Revisions made to publication P1020.06 Rev/ 0.6 (5/11)
Total Revision.

Previous Design:

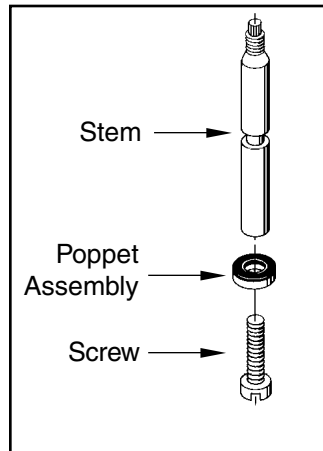
@6 Note: Poppet Assembly (527290-XXX) was Obsoleted 6/1/00. Replacement Components are:

To Upgrade, Replace Stem, Poppet Assembly, and Screw with Item #21 Stem (P/N 529520-004), Item #14 O-Ring Retainer (P/N 529659-003), and Item #26 O-Ring (Select Elastomer Required).
